PROJECT: MESA ELEMENTARY SCHOOL  
RELOCATION OF MODULAR CLASSROOMS  
DSA File No.: 19-25  
DSA Application No.: 03-117500  
GBA Project No.: 1633

ADDENDUM NO. 2

Date: April 15, 2019  
Owner: Covina Valley Unified School District  
519 E. Badillo Street  
Covina, CA 91723  
Architect: Ghataode Bannon Architects LLP  
760 W. 16th Street - Unit B  
Costa Mesa, CA 92627  
(714) 665-8030

**SKETCH NO. SK-1**

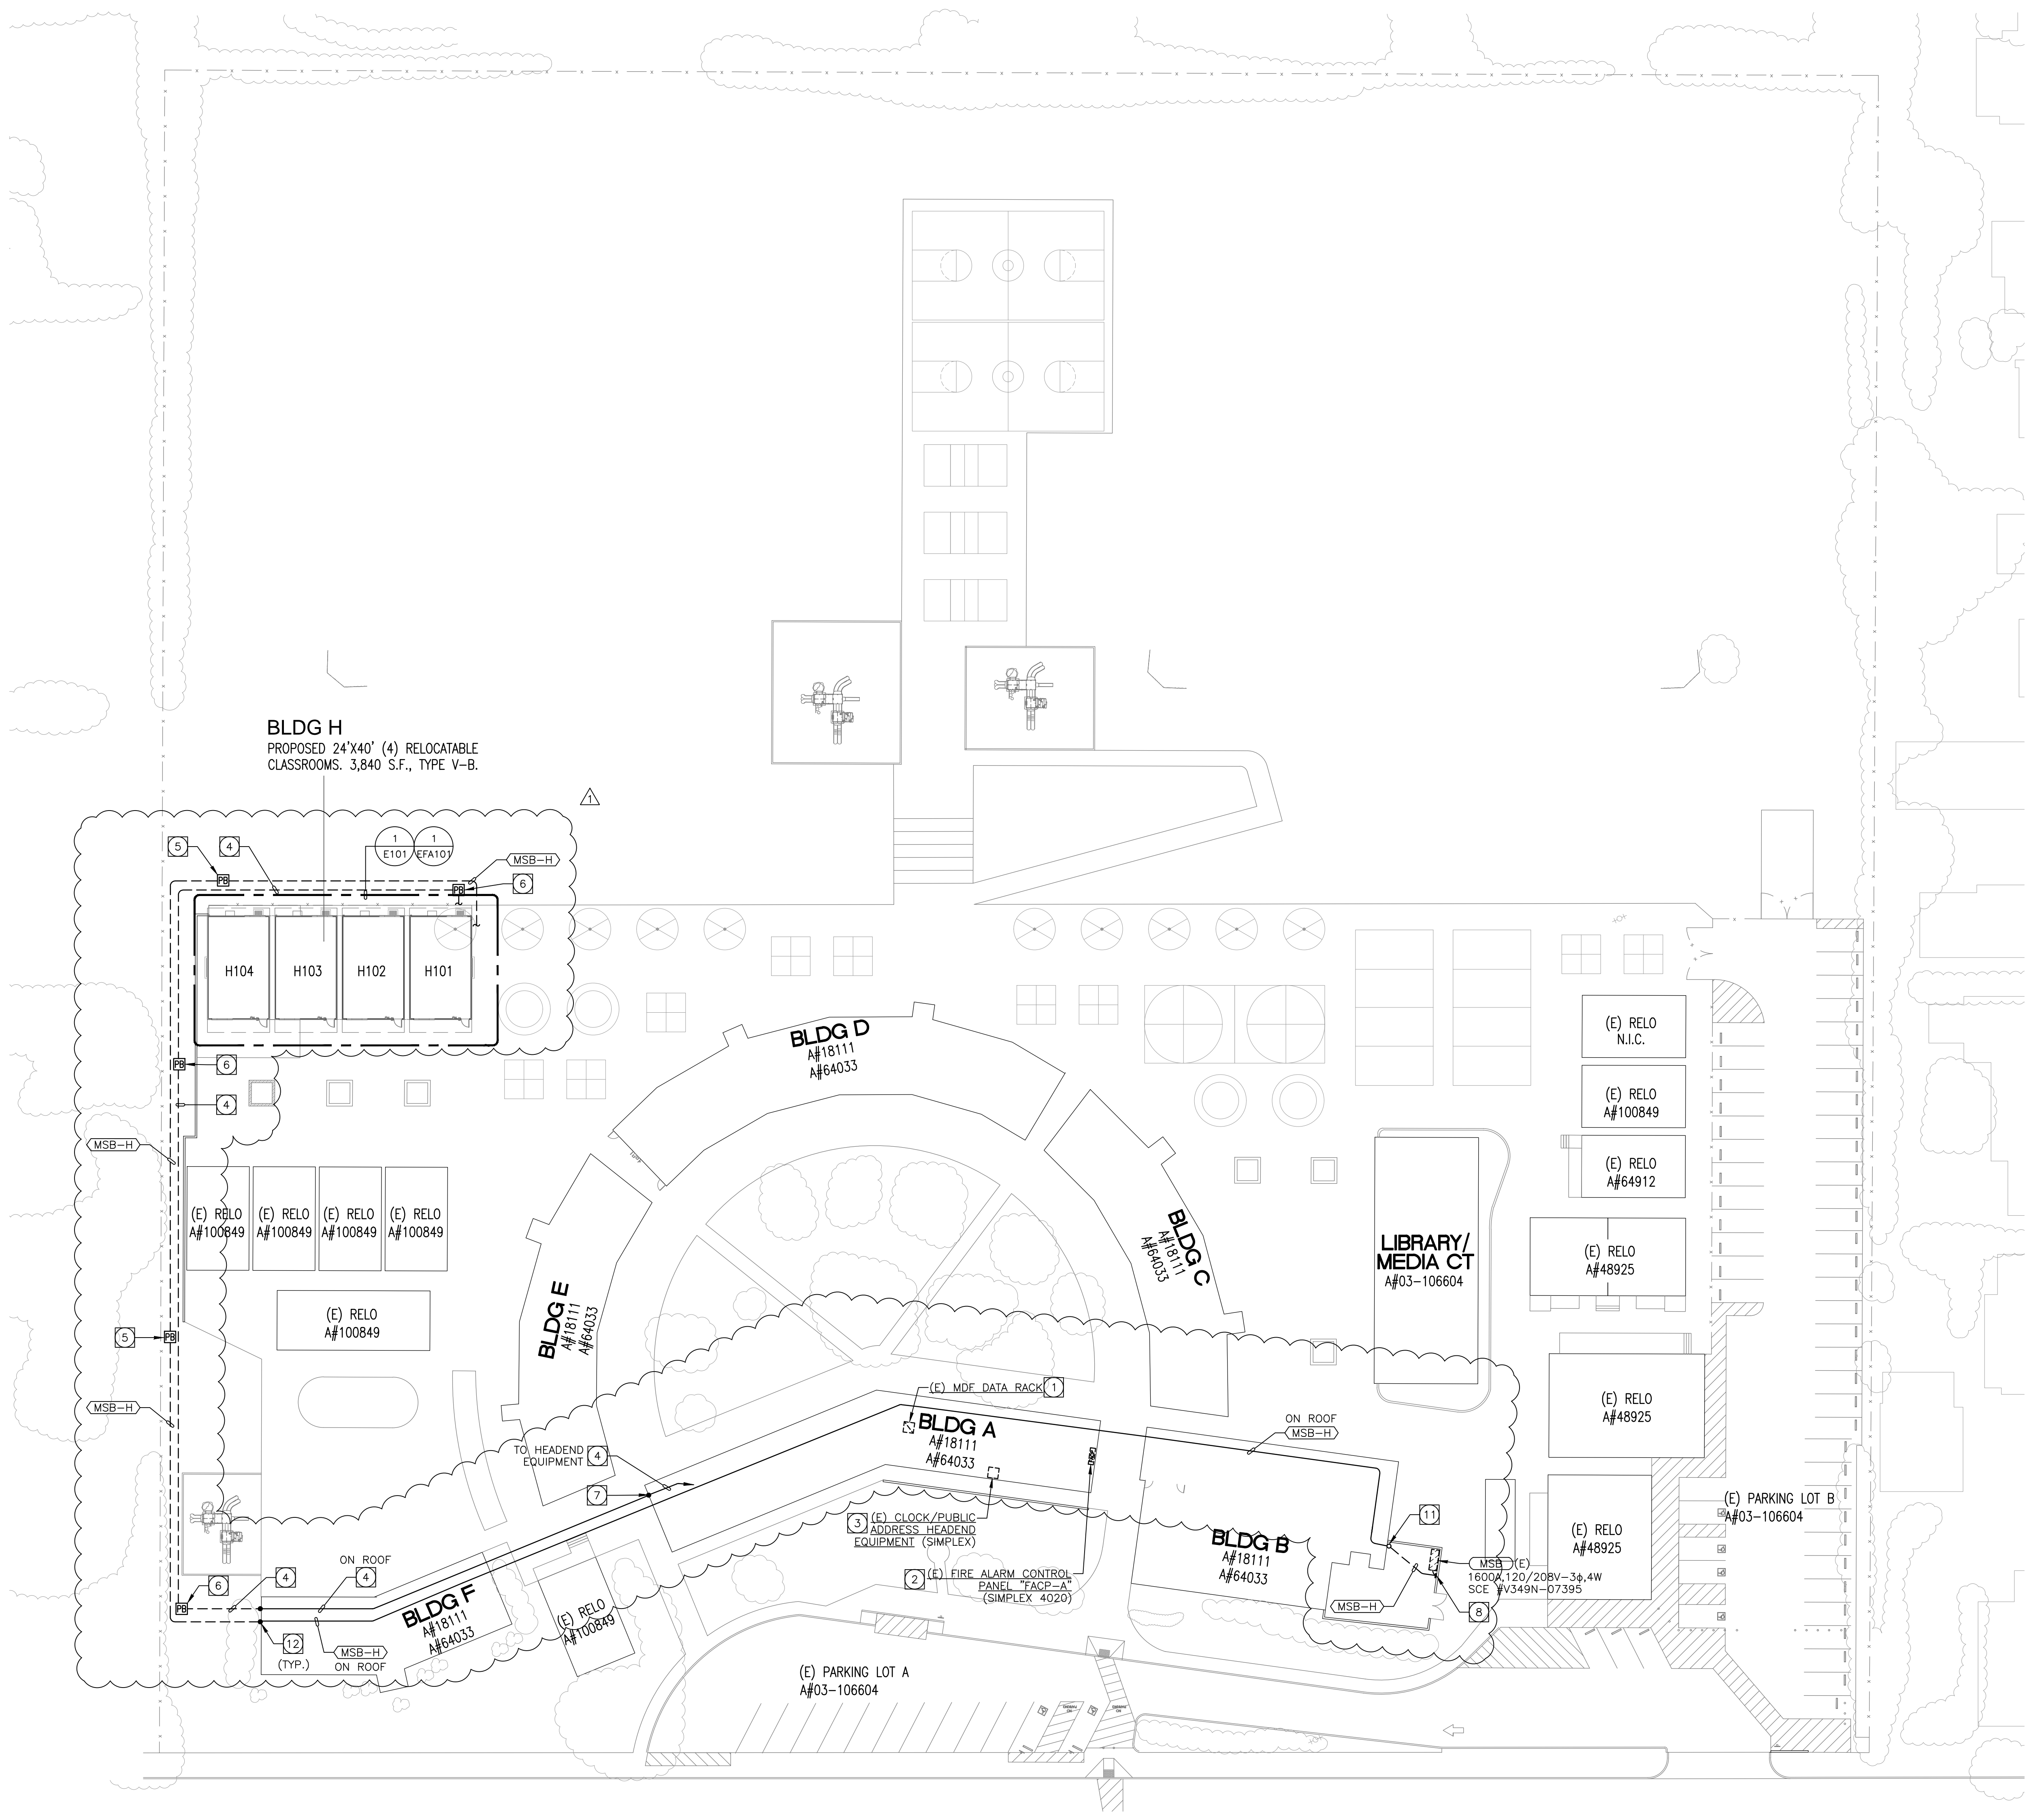
Description: Refer to attached Sketch SK-1 for improvements at Sierra Vista Middle School as follows:

Remove, move and re-install four (4) (E) relocatable buildings from the Sierra Vista Middle School to the Mesa Elementary School. Re-program the existing fire alarm system at Sierra Vista Middle School to remove the four buildings from the program.

Remove existing C.L. fencing and pull wire as indicated.

Provide AC paving and base patch-back as indicated. Provide C.L. fencing and gates.

FOUR (4) (E) RELOCATABLE BUILDINGS WITH RAMPS TO BE REMOVED, MOVED TO AND INSTALLED AT MESA ELEMENTARY SCHOOL. RE-PROGRAM (E) FIRE ALARM TO REMOVE BUILDINGS FROM PROGRAM.

(E) PULLBOXES TO REMAIN. REMOVE (PULL) WIRE TO LEAVE EMPTY CONDUIT.

INSTALL AC PAVING SECTION TO MATCH EXISTING. ALLOW 3" AC OVER 9" BASE. JOIN (E) W/ FLUSH TRANSITION.

(N) 8' TALL CHAIN LINK FENCE, 9 GA, 2" DIAMOND MESH, GALV., TYP. 4' WIDE GATE W/ LOCKABLE HASP

REMOVE (E) CHAIN LINK FENCE AND GATES

**E001**  
SHEET - OF XXX  
XREF:

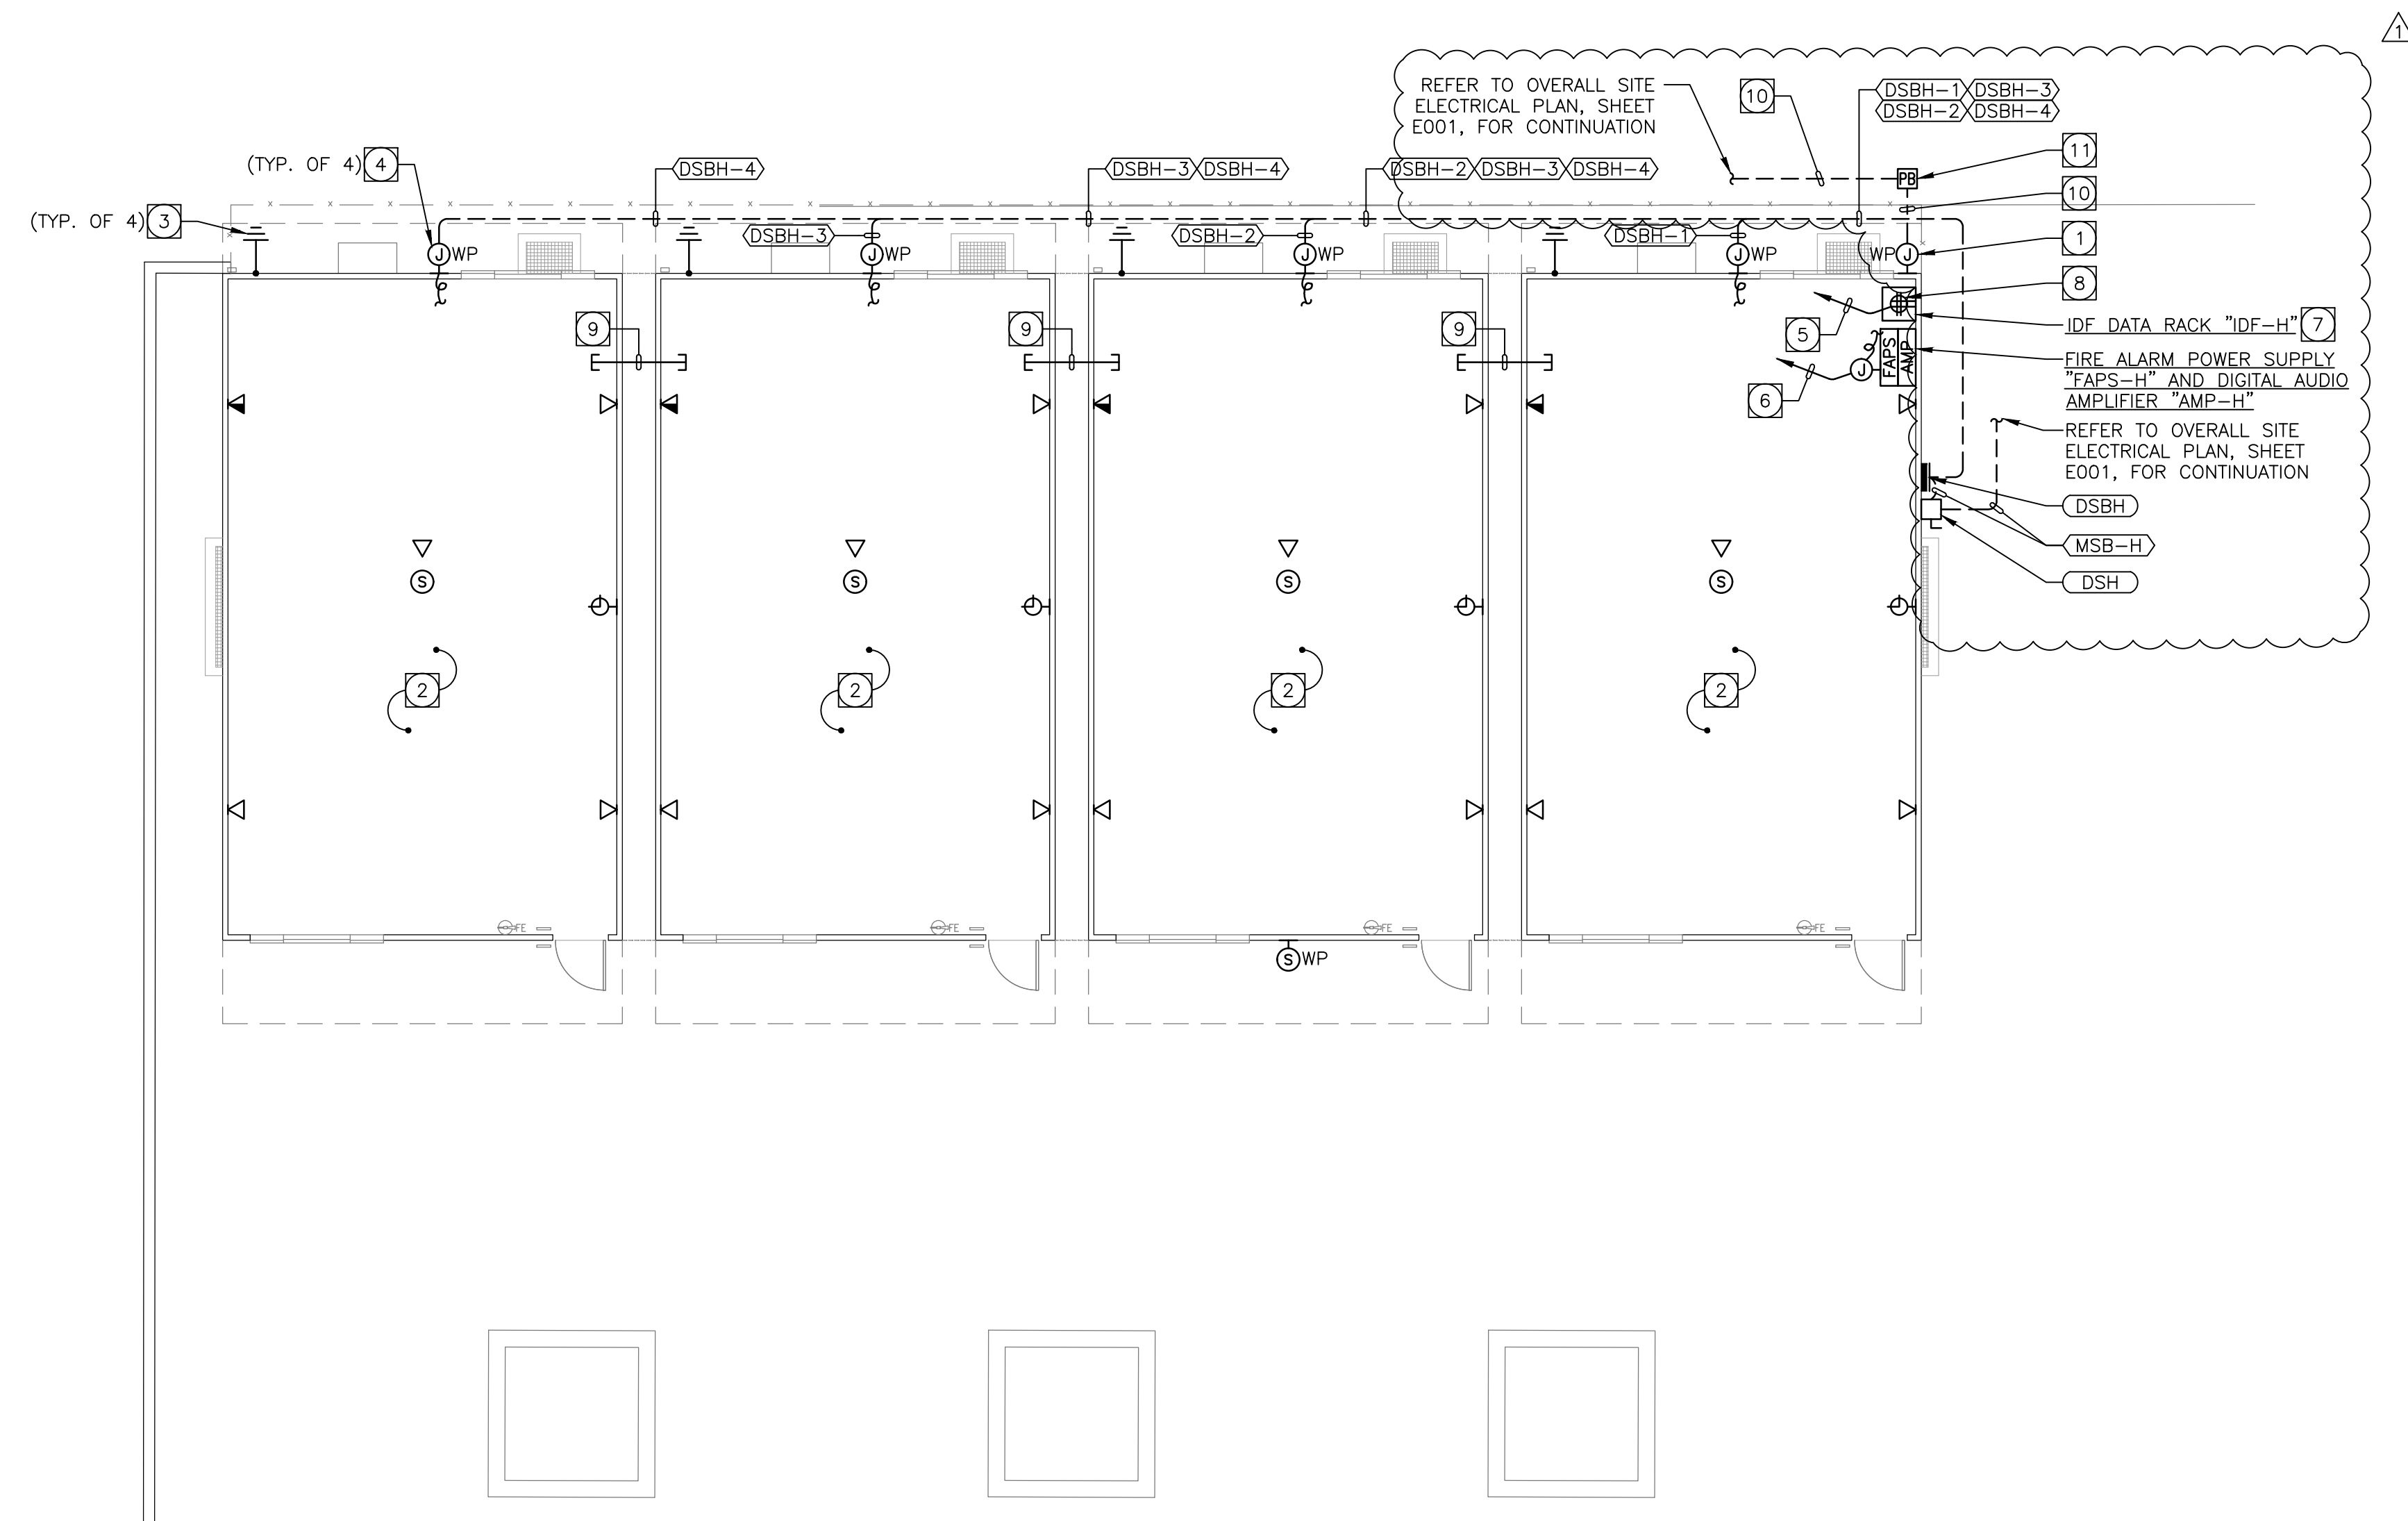
E001 SITE ELECTRICAL PLAN

Reroute power and data pathways per attached E001 Site Electrical Plan.
